# REGIONAL REVIEW NOTIFICATION

**ARC REVIEW CODE:** R2003091

**Name of Proposal:** Woodward Mill Road Tract (DRI #3050)

**OVERALL DRI PLAN**

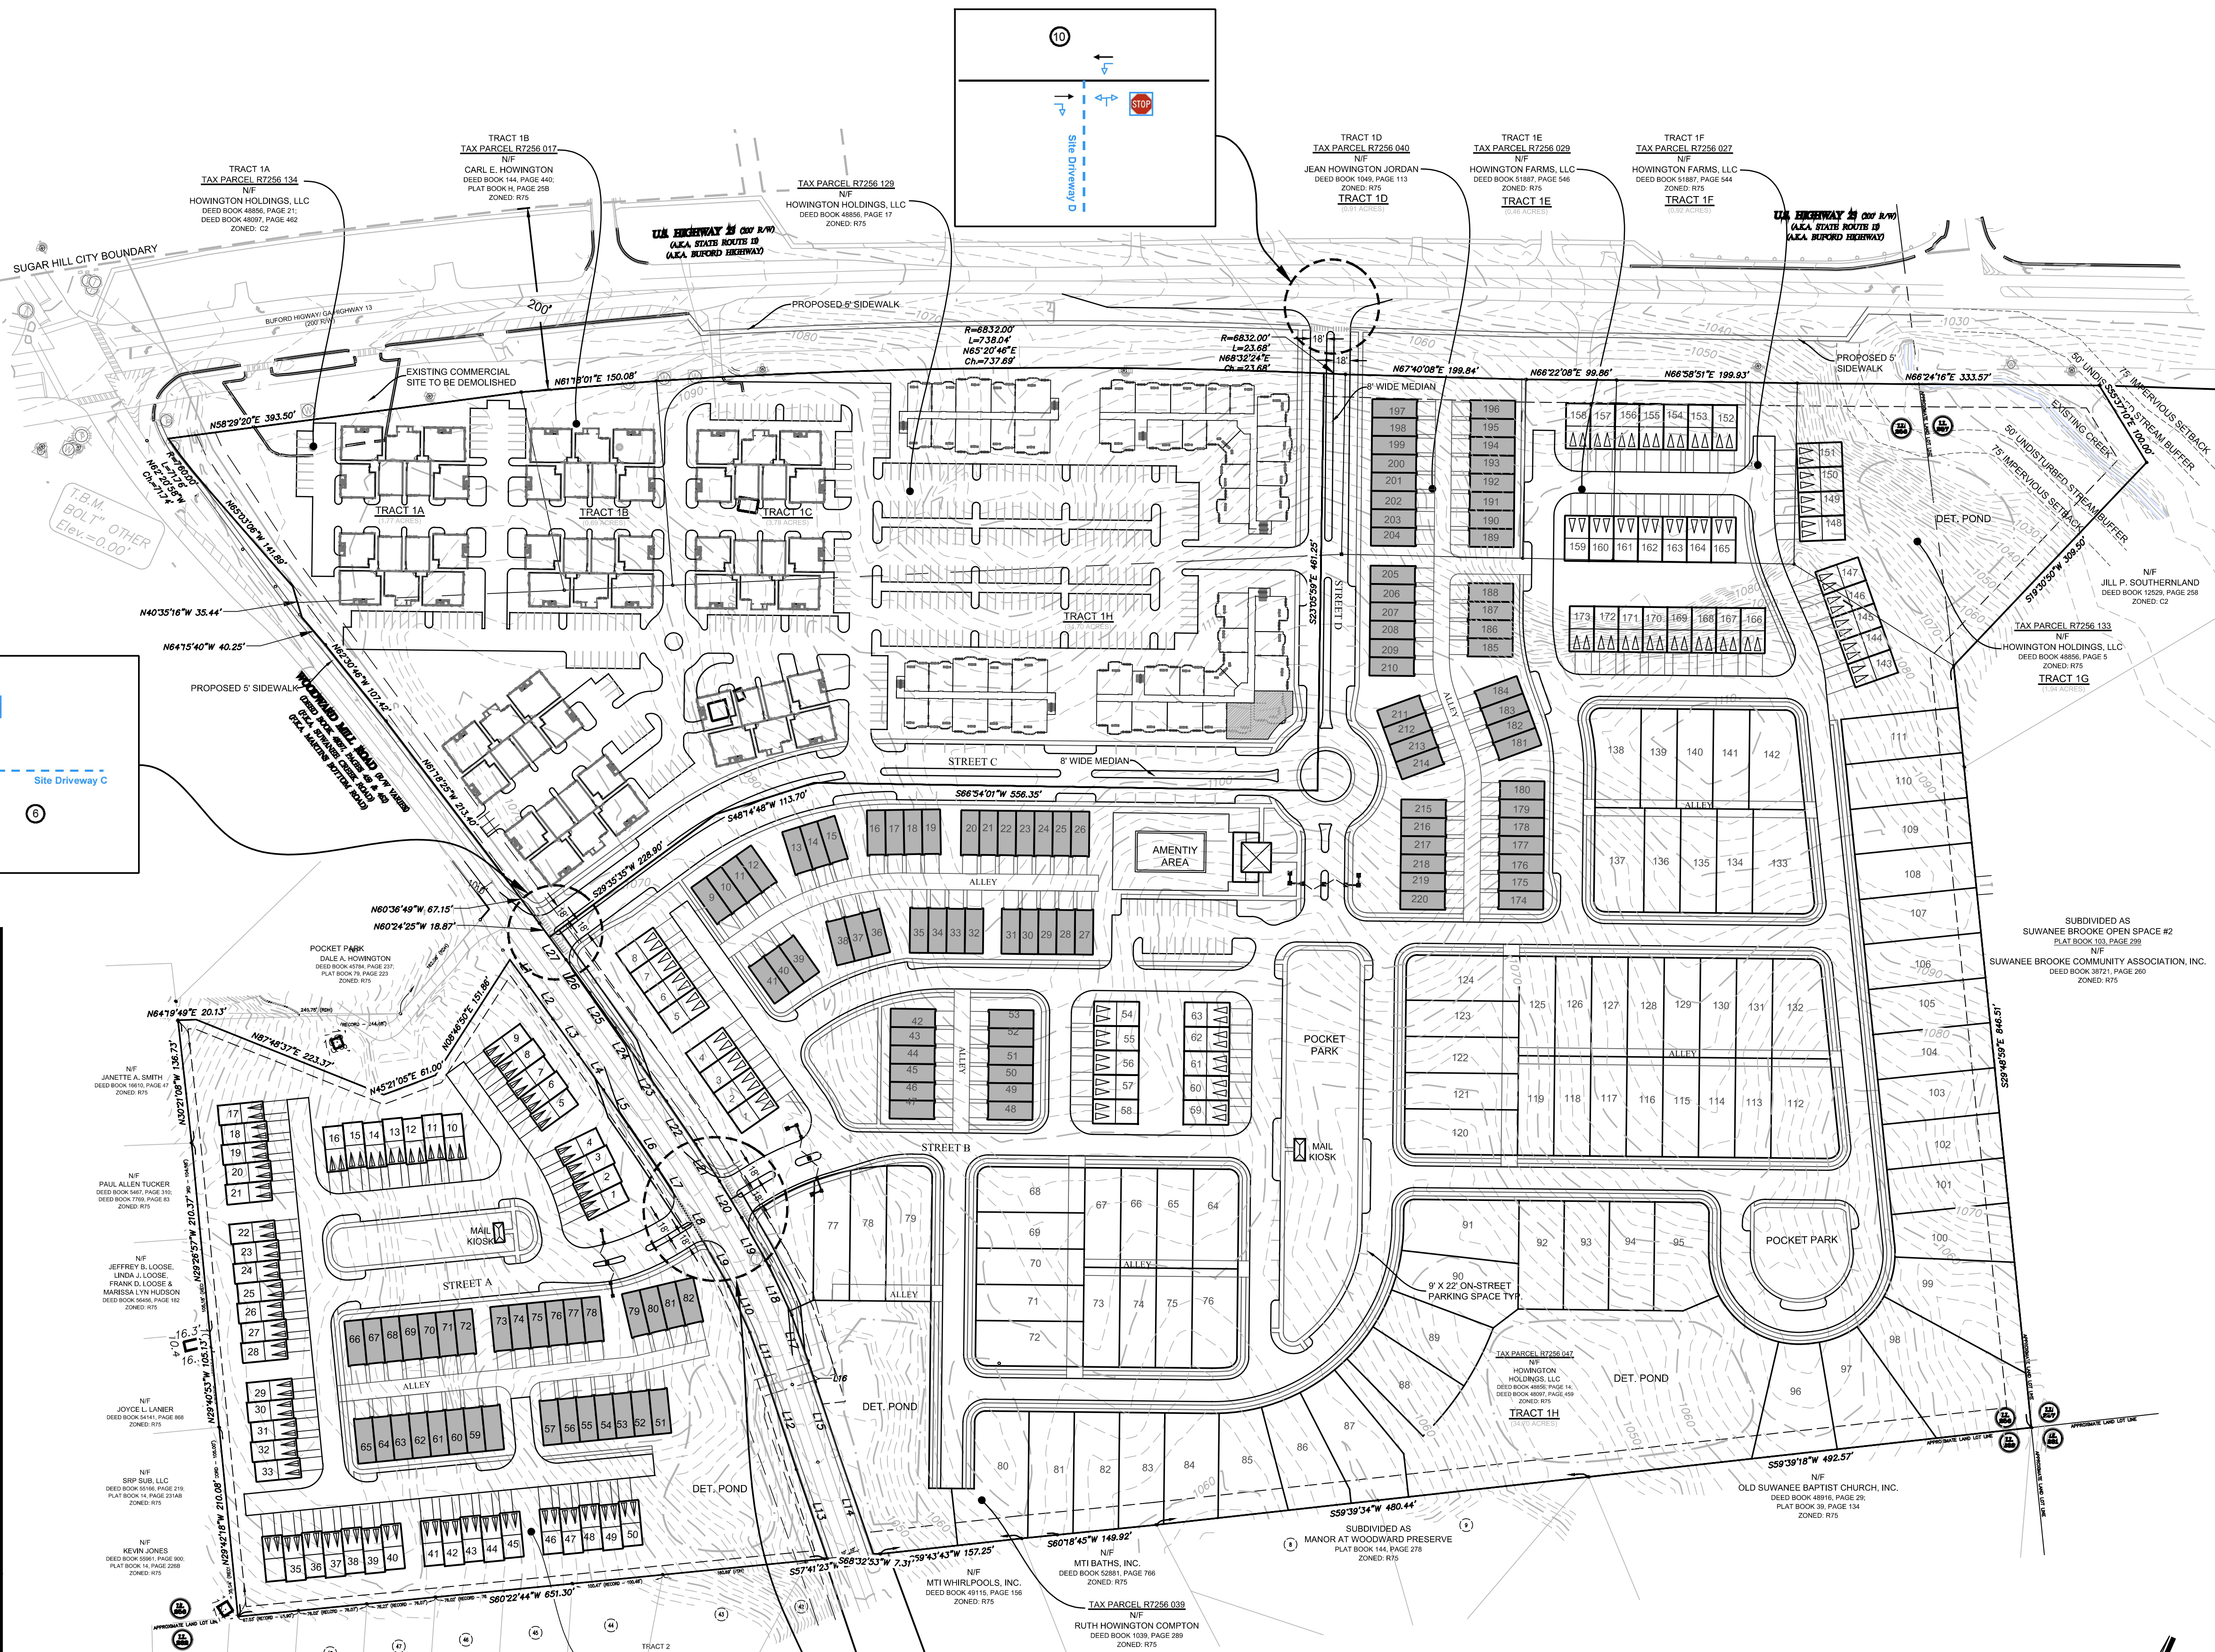
ARC's policy guidance for Developed/Established Suburbs mentions that new development should connect to the existing road network and adjacent developments, and use of cul-de-sacs or other means resulting in disconnected subdivisions, should be discouraged. This DRI features appropriate internal street

connectivity, along with an off-street trail network, its site design does not appear to contemplate potential future connections to adjacent properties other than to the south next to Woodward Mill Road.

This DRI appears to manifest certain aspects of regional policy. It offers a variety of housing types and sizes. It incorporates parks and amenities at multiple locations. Streets C and D are a major improvement to previous iterations of the plan, by opening up access across the different housing types and offering on-street parking, medians, and sidewalks. It's not clear if all the amenities are intended and accessible to all residents of the DRI. The current site plan proposes gated access for vehicles to enter the detached single-family home and townhome portions of the eastern half of the site. Even if this gated access remains for vehicles, pedestrian access should be maintained for access to the amenities.

It is absolutely critical that the Gwinnett County Department of Transportation, Gwinnett County Public Schools, and Georgia Department of Transportation coordinate as soon as possible to facilitate a safe pedestrian crossing for students and other residents to access Lanier High School and its various community and athletic facilities. There is major potential for students living in the proposed DRI to walk to school if a safe crossing for Buford Highway is provided, ideally near the northeastern corner of the DRI and the western entrance for the school campus. Planning in advance for safe and comfortable pedestrian access to major community facilities is essential to mitigating long-term traffic impacts to the surrounding area.

The gross residential density of this DRI (10.15 units per acre) is above the ARC RDG's recommended development parameters for Developing Suburbs (up to 5 units per acre). Otherwise, the development appears to be largely compatible with recommendations for the Established Neighborhoods Character Area in the Gwinnett County 2040 Unified Plan. Mixed residential developments like this are listed as potential development types.

Both the site plan and the USGS coverage for the project area show one blue line tributary to Suwanee Creek running across the property in the northern portion of the property near Buford Highway. No development is shown in this area and the Gwinnett County 50-foot stream buffer and 75-foot impervious setback are both shown along the stream. These buffers may also apply to any unmapped streams on the property. This stream, any other streams, and any other waters of the state on the property are also subject to the State 25-foot Sediment and Erosion Control buffer.
